BULLETIN

According to experience from flying with airplanes UFM 10 Samba and Samba XXL Urban Air s.r.o. company issued following bulletin

1.UA.2007

Obr. 1.

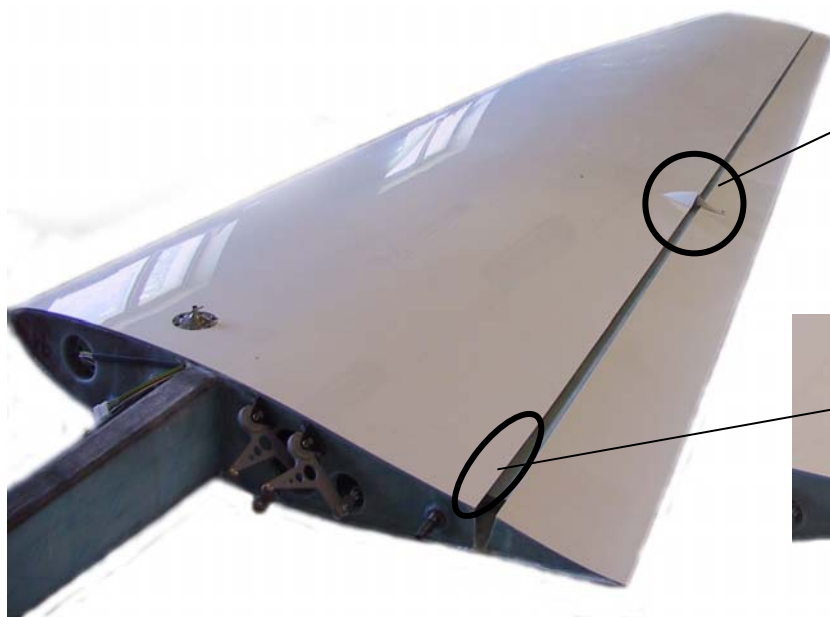
Company Urban Air prescribe make valid immediatelly change of flaperon pushrod laminated covers on left and right wing (see photo No. 1) on the airplanes UFM 13 Lambada.

We found, that on maximum load of the wing (flight envelope limits) deflection of the wing can make situation, when pushrod connection screw touch the laminated cover. Also bottom surface on the left and right wing can touch the flaperon. Because of this two reasons forcer on the control stic can increase.

It is necessary to make change of small laminated covers of flaperons for new – bigger ones and grind away part of bottom surface on the left and right wing. Then movement of control lines is free on all points of flight envelope.
